Application for URBAN DESIGN COMMITTEE Review

RE: City of Richmond Department of Public Works - Commerce Road Complex

The City of Richmond Department of Public Works is submitting this application for final approval for the construction of two new buildings on the Commerce Road Complex. The Conceptual Plan was reviewed and approved conditionally by the UDC on the March 5th meeting with the following comments:

E + LANDSCAPING PLAN

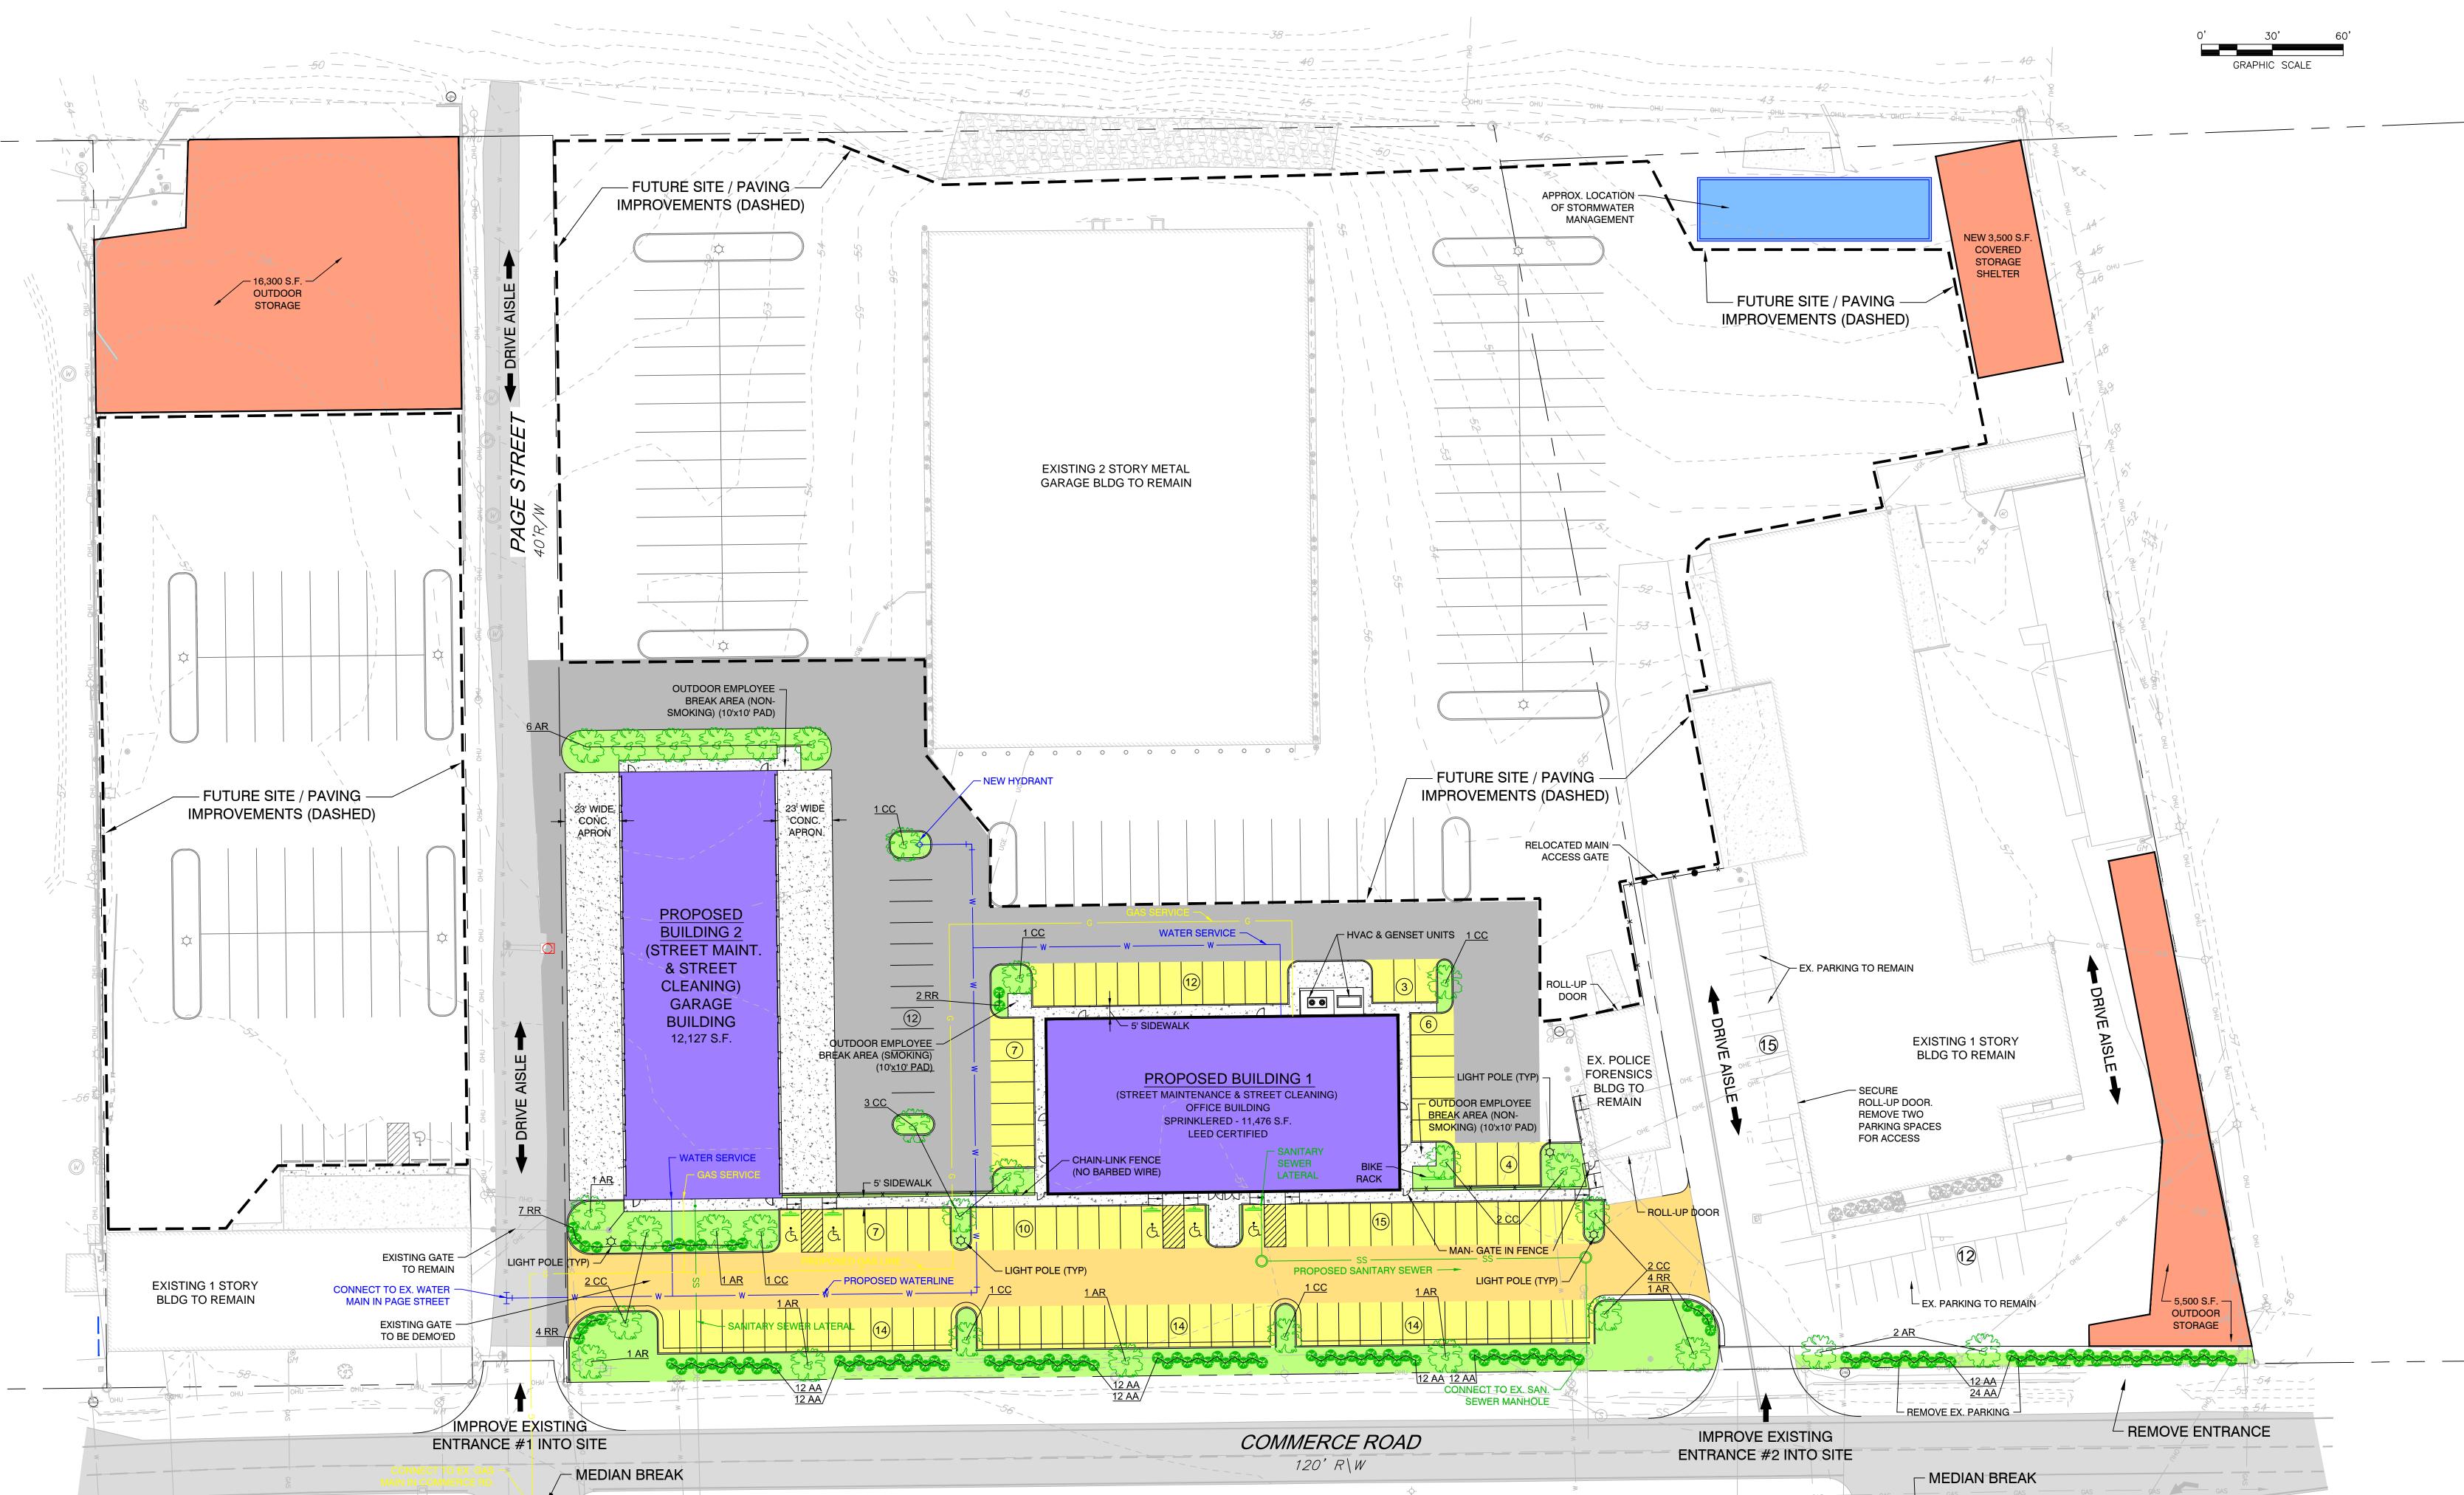
- The final plans include a landscaping plan, showing plant species, quantity, location and size at the time of installation.
- That the applicant considers providing landscaping and/or an architectural treatment along the Commerce Road side of Building 2 to break up the large blank façade.

- That the outdoor employee break area adjacent to the office building be located in a landscaped area rather than next to the mechanical equipment.
- That a similar outdoor break area be located adjacent to the garage building.

- The final site plans include a detailed landscaping plan and planting schedule including plant type, size, and quantity. The final landscape design incorporates Red Maple and Red Eastern Redbud trees which provide shade canopy coverage with shrubbery interspersed throughout the site. All plantings following the "Recommended Plant Species" list included in Appendix 5 of the City of Richmond Urban Design Guidelines.
- The provided landscape plan includes an enhanced landscape area on the Commerce Road side of Building 2. As requested, the design incorporates attractive tree and shrubbery plantings designed to complements and soften the proposed building exterior. Red maple trees are included

- The outdoor employee break area associated with Building 1 has been relocated to a landscape island on the southwest corner of the proposed building. A shade tree is located adjacent to the break area to provide shade and cover for the employees.

- Per the UDC suggestion, a similar outdoor break area has been provided adjacent to Building 2.
 This break area is located on the southeast corner of the building in a shaded landscape island.
